Assessing new nuclear power station designs

Generic design assessment of Hitachi-GE Nuclear Energy Limited's UK Advanced Boiling Water Reactor

Consultation document

12 December 2016

Fig 9.1: Mean normalised annual gaseous tritium discharges for BWRs 2005 – 2013. Pink line shows normalised UK ABWR estimated annual gaseous tritium discharges.

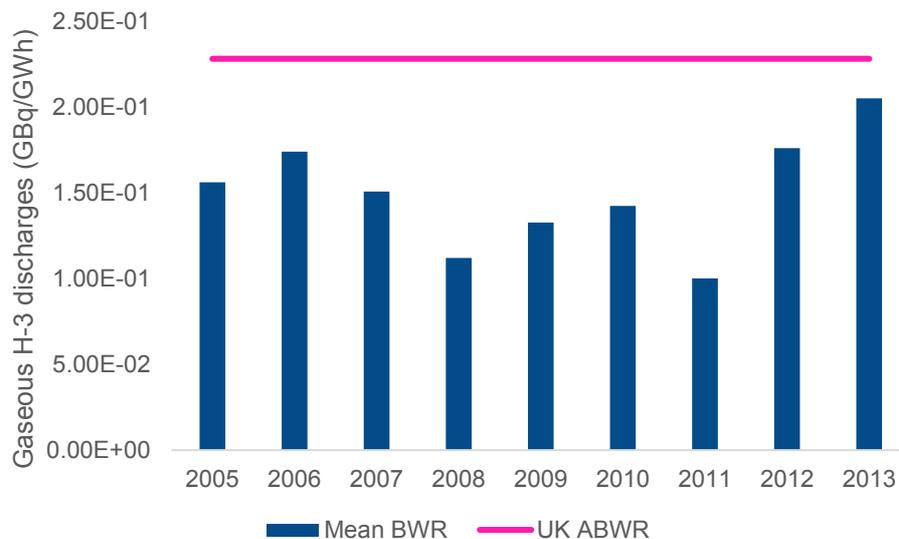
252. Estimated annual discharges of gaseous tritium from the UK ABWR are higher than the mean annual discharges of gaseous tritium from other operating BWRs, but sit within the range of data obtained for operating BWRs. Hitachi-GE suggests that the reason for the apparently high gaseous tritium discharge for the UK ABWR when compared with other reactors is because it has used conservative assumptions when estimating tritium discharges. For tritium discharge estimates, Hitachi-GE has assumed a maximum steam flow rate in the turbine gland steam system that maximises the tritium discharge via this route. However, during operation, the steam flow rate is expected to be lower.

Fig 9.5: Mean normalised annual gaseous carbon-14 discharges from BWRs 2005 – 2013. Pink line shows normalised UK ABWR estimated annual gaseous carbon-14 discharges.

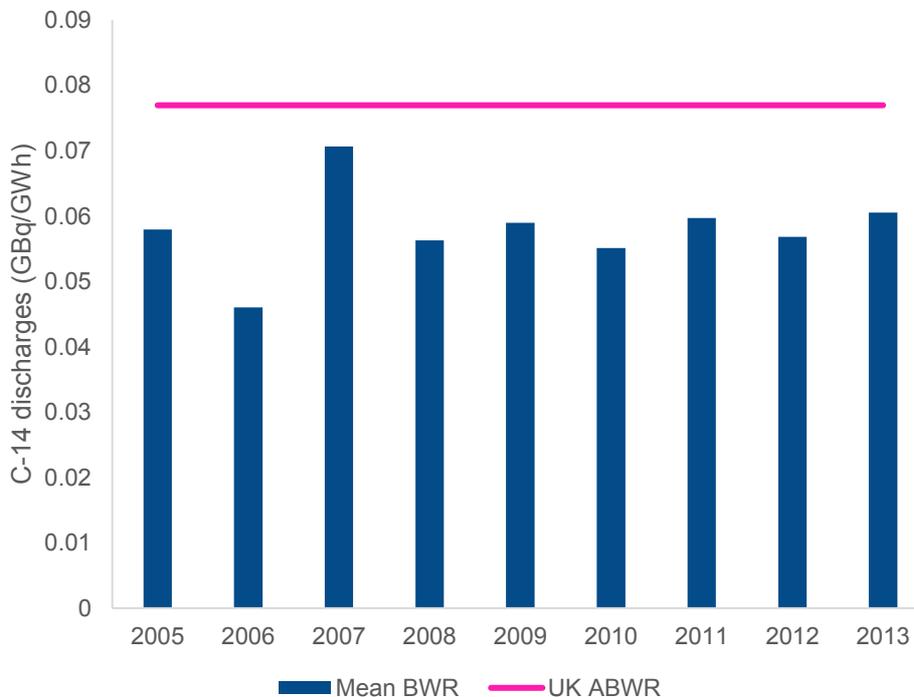
260. Estimated annual discharges of gaseous carbon-14 from the UK ABWR are higher than the mean annual discharges of gaseous carbon-14 from other operating BWRs but sit within the range of data obtained for operating BWRs. We are requesting further information on this matter and will consider the response when it has been submitted and report on it in our final decision document.
